Detailed Site Plan Walker Mill Self-Storage

DSP-23012

STAFF REPORT

SUBJECT: Detailed Site Plan DSP-23012
Type 2 Tree Conservation Plan TCP2-027-2020-01
Walker Mill Self-Storage

Figure 1: Site Plan

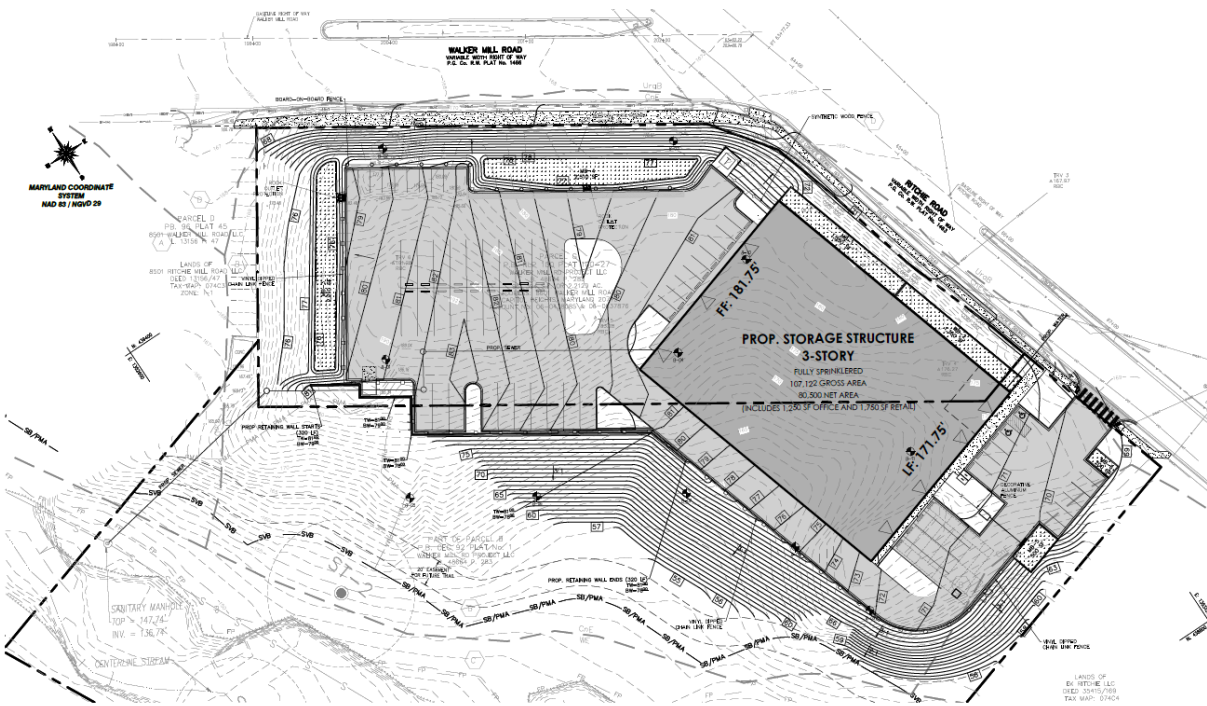
The site has one vehicular entry/exit point on Ritchie Road, with a crosswalk for pedestrian connectivity. Sidewalks are provided along both frontages of Walker Mill Road and Ritchie Road. A pedestrian path is also provided to connect the sidewalk on Ritchie Road to the building entrances on the south side of the building.

A parking area with 12 parking spaces is located in front of the building when entering the site. These parking spaces are primarily for visitors. A security gate is located at the end of this front parking area, for those who work and use the consolidated storage facility. Four loading spaces are located immediately behind the security gate. Through a driveway along the west side of the building, employees and users of the proposed development can access parking and loading spaces located at the rear of the building. The parking area at the rear of the building also houses 28 parking spaces for RV/camping trailers, as an accessory use to the proposed development.

Figure 3: East Elevation along Ritchie Road

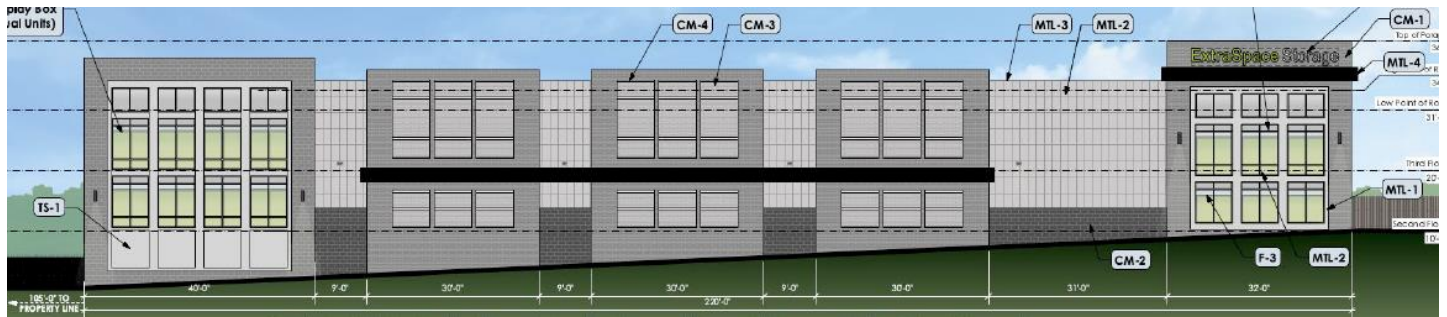
The building has variation in the parapet height. Specifically, the design of a slightly raised roof parapet is to highlight the entrances to office/retail/community space on the southeast corner of the building, as well as for the installation of the two building-mounted signs situating at the northeast corner of the building. Each entrance to the building is also paired with an awning for accenting these entrances.

Figure 5: Two Storage Facilities within One-Half mile of the subject DSP

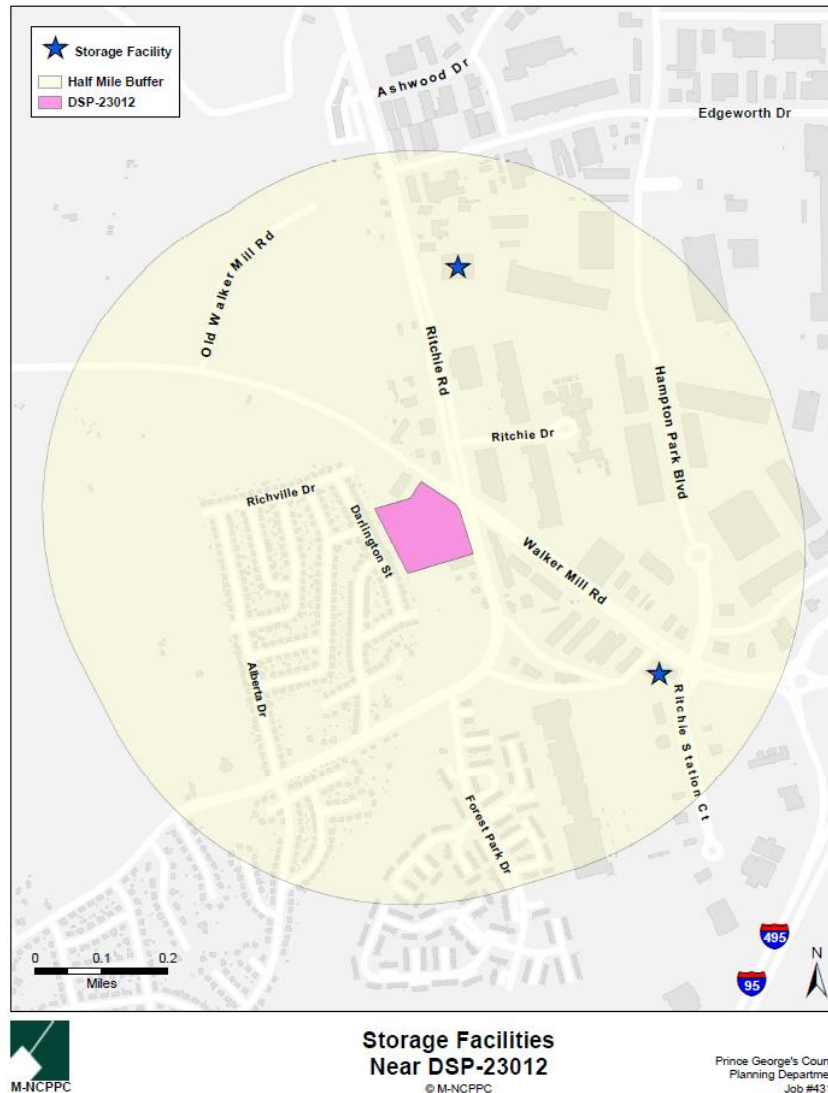
The subject DSP was submitted in fulfillment of this requirement. Regarding the current, countywide inventory of consolidated storage uses, it is noted that there are two other consolidated storage facilities located within one-half mile of the property. Both storage facilities are located within the boundary of Capital Heights, in Maryland. The first one is CubeSmart Self Storage, located at 1501 Ritchie Station Court. CubeSmart Self Storage was approved by the Planning Board on March 12, 2012 (PGCPB Resolution No. 12-19), subject to two conditions. The second one is Public Storage, located at 800 Ritchie Road. Public Storage was approved by the Planning Board on March 26, 2020 (PGCPB Resolution No. 2020-42), subject to two conditions. Staff find that these conditions were related to the approval and permits of the associated application, and do not conflict with the subject DSP.
